Project Name: Hirfynydd Renewable Energy Park

Site Address: Land to the east of Crynant, Neath Port Talbot

Proposed Development: Renewable energy park comprising wind generating capacity, solar photovoltaic generating capacity and battery storage.

I write in regards to your letter dated 25 October 2022, which seeks advice on the scope of the EIA for the above mentioned proposed DNS renewable energy project. Consideration has been given to the information provided in the EIA Scoping Report prepared by LUC and the questions raised therein, together with the relevant regulations and information that the Authority holds. Our advice is set out below in response to the respective chapters, the questions raised by the applicant and with reference to Schedule 4 of the Town and Country Planning (Environmental Impact Assessment) (Wales) Regulations 2017 ('the 2017 EIA Regulations').

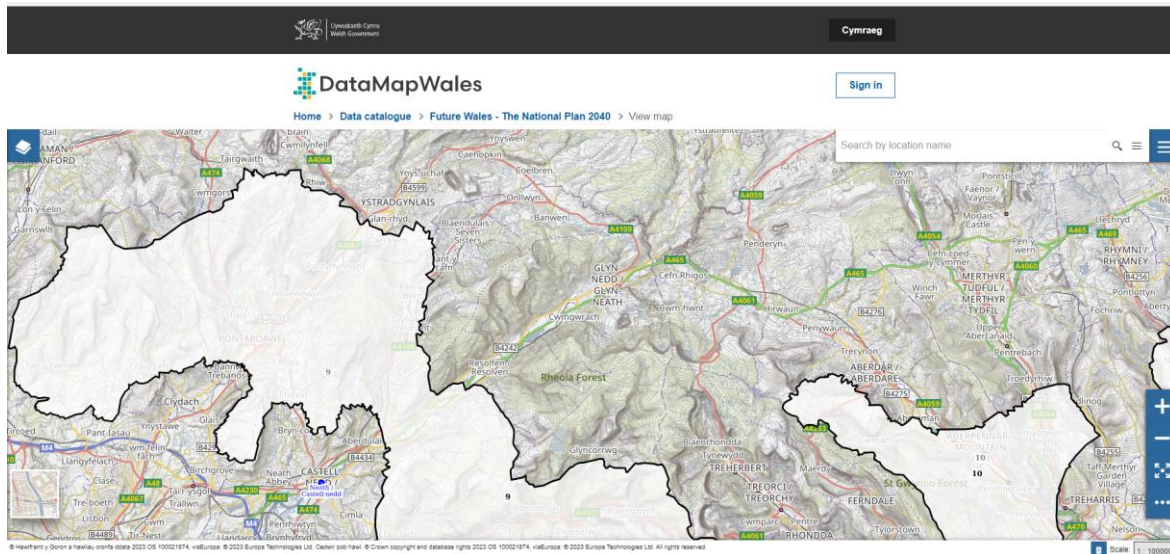
The application site is clearly outside of the pre-assessed wind areas identified within Future Wales, as illustrated in the map below:

From 2005 the previous national planning policy for onshore wind development was based on Technical Advice Note ('TAN') 8. This defined a series of strategic search areas ('SSAs') and the proposed site lay within Area E. It is therefore notable that the site has now been excluded from the Policy 17 pre-assessed area.

The Authority concurs with the sentence, contained at para.3.17, that *"as the most recent expression of national planning policy, Future Wales is considered to have primacy in the planning policy hierarchy"*. The previous SSA boundaries (and former TAN 8 policy) are revoked and have been superseded by the new pre-assessed wind areas contained within Future Wales.
